Subject: Calico Solar 08-AFC-13C  
Applicant's Response to CEC Data Requests Set 1 (1-37)

## Applicant's Response to CEC Data Requests Set 1 (1-37)

CALICO SOLAR PROJECT

**Calico Solar**  
**Responses to CEC Data Requests**  
**Data Request Set 1 - Requests 1-37**  
**08-AFC-13C**

**kRoad**  
2600 10th Street  
Suite 635  
Berkeley, CA 94710

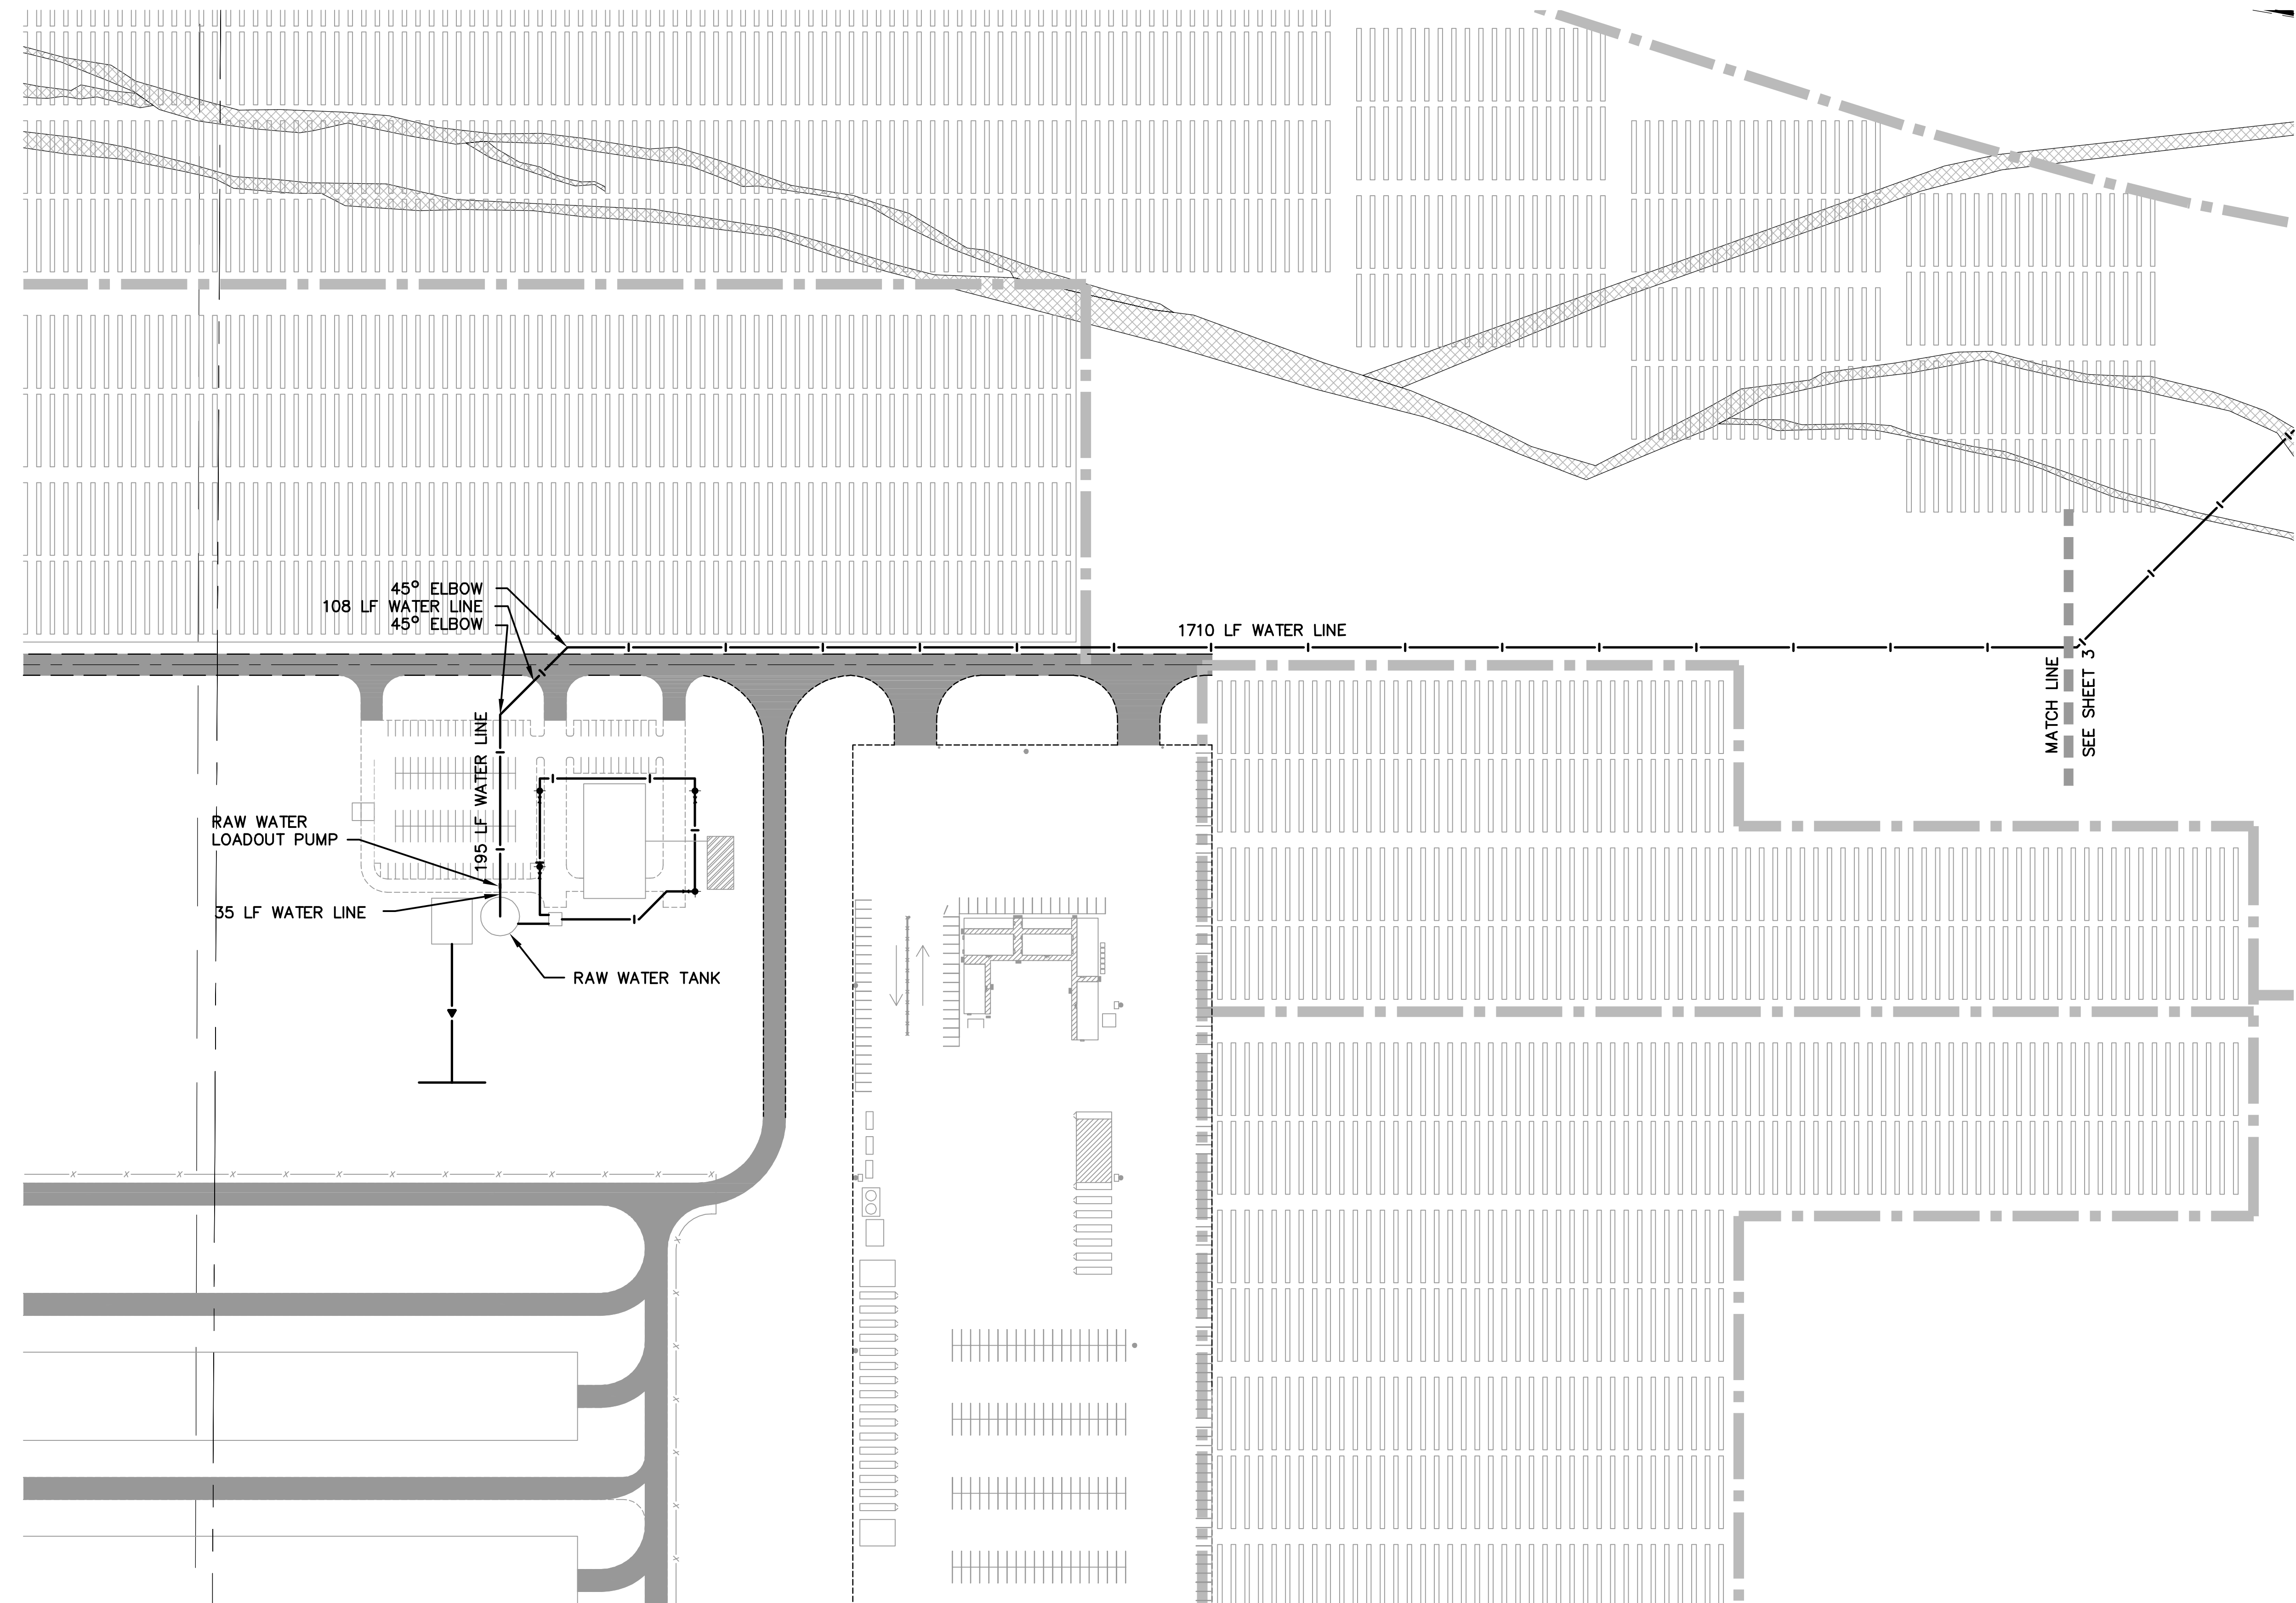
Please provide the construction design of the water line from the well head to the main services complex.

Horizontal plan views of waterline from the connection to the existing well to the Main Service Complex and details of the typical trenching and thrust blocking have been included (please see attachment SWR-1).

**SWR-4**

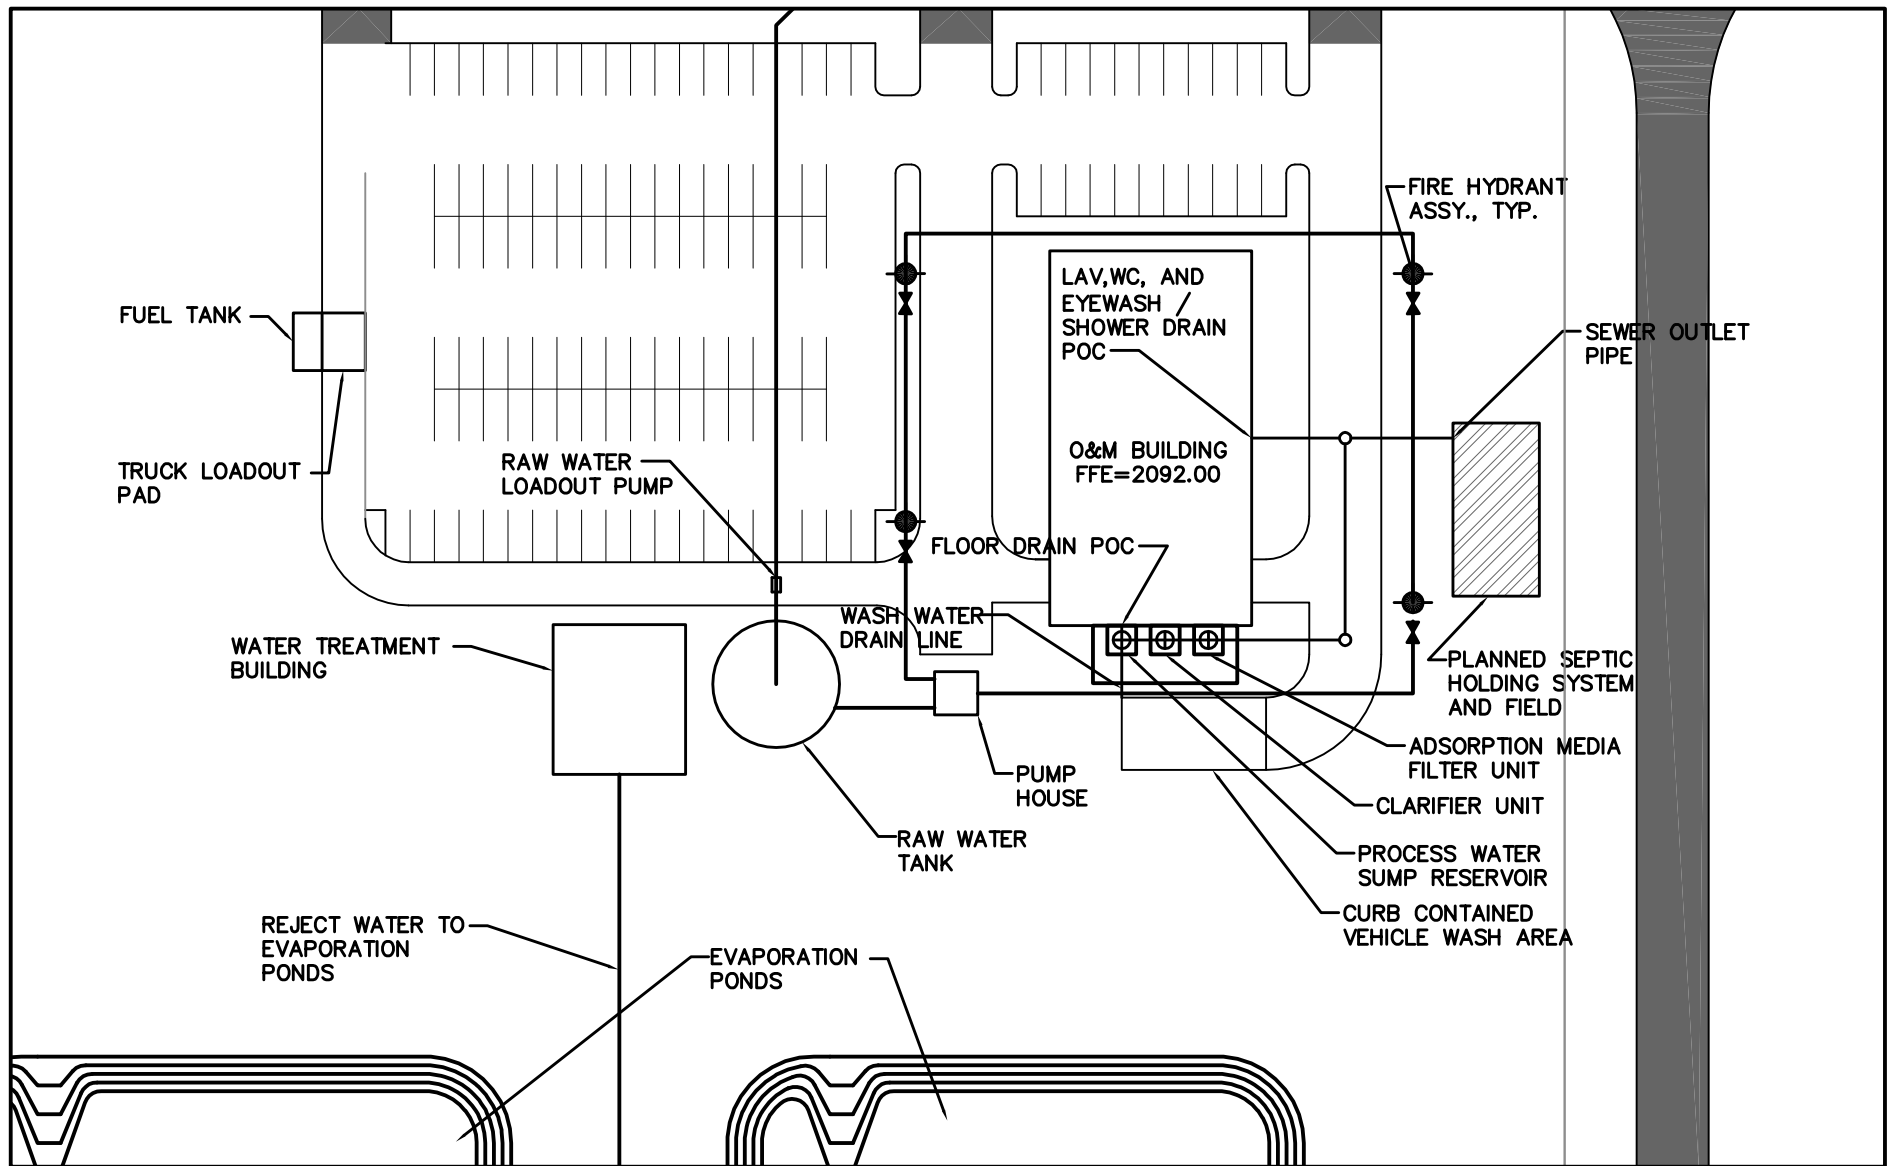
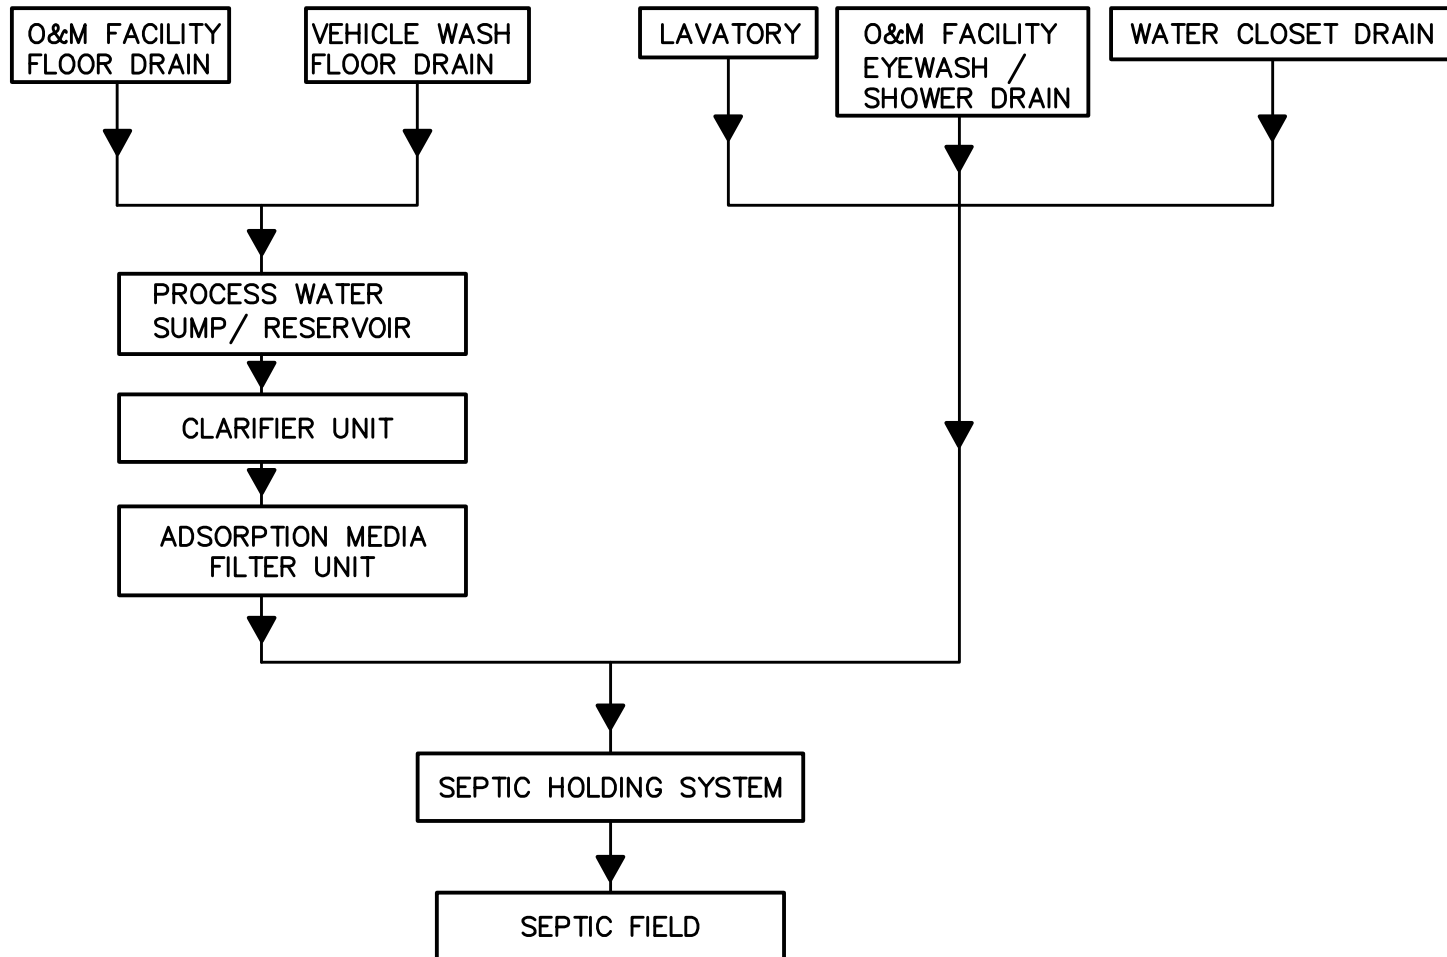
**Data Request 23.** Please provide the design of the wastewater recycling system.

The preliminary site plan layout is presented in attachment SWR-3 (also provided as the response to Data Request No. 24). A preliminary schematic diagram for the wastewater recycling system process is provided as attachment SWR-4.
